Engineering Referral Response

Application Number:	DA2023/1933
Proposed Development:	Alterations and additions to a dwelling house including a double carport
Date:	27/05/2024
To:	Reeve Cocks
Land to be developed (Address):	Lot C DP 162702 , 31 Montauban Avenue SEAFORTH NSW 2092

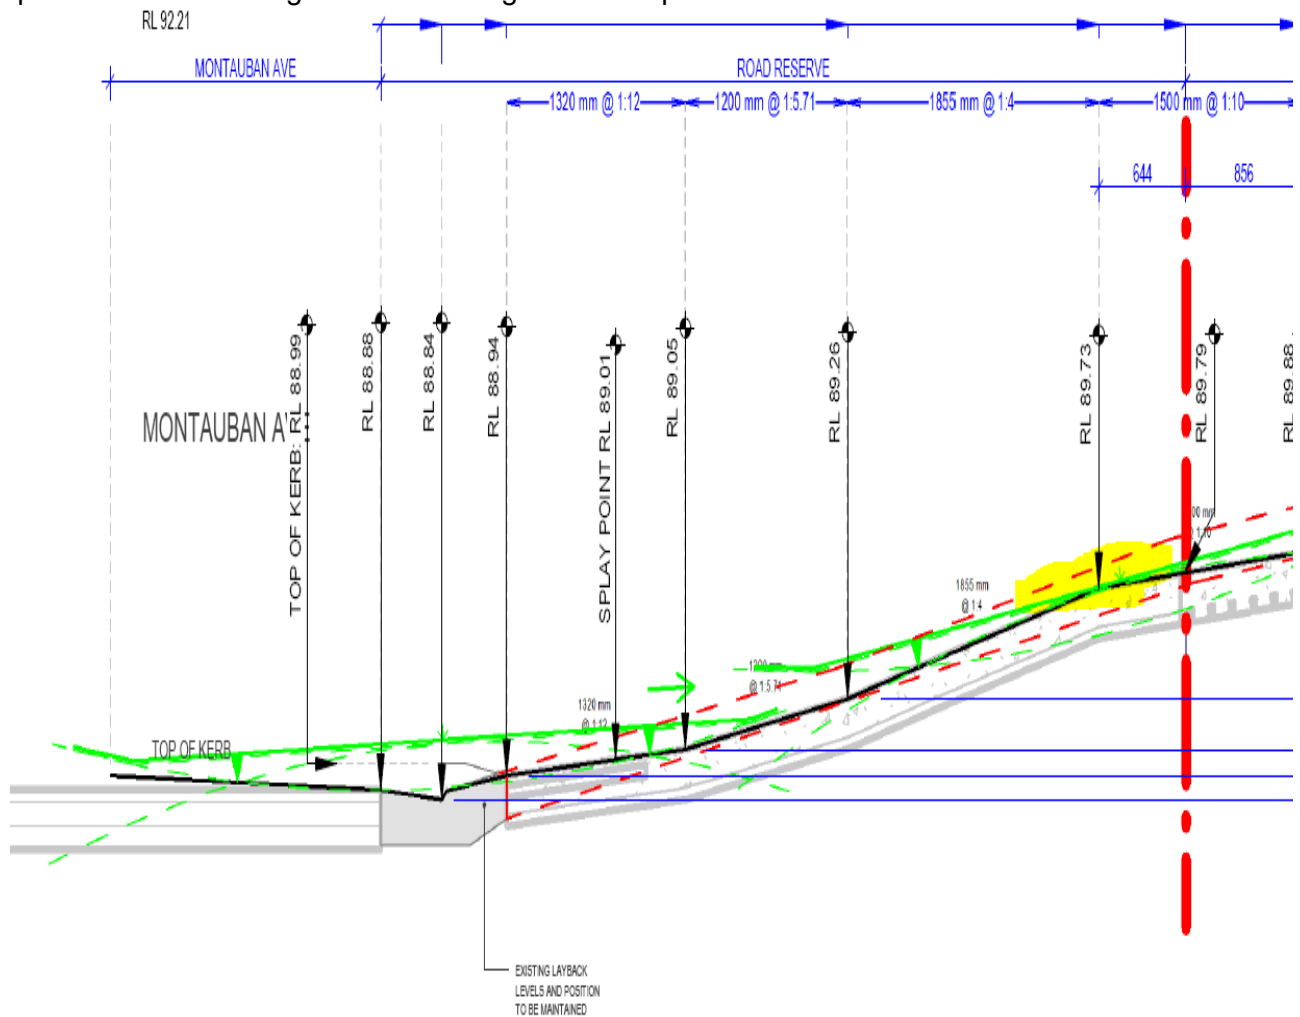
The submitted stormwater plan with the proposed discharge via the existing connection is acceptable subject to conditions.
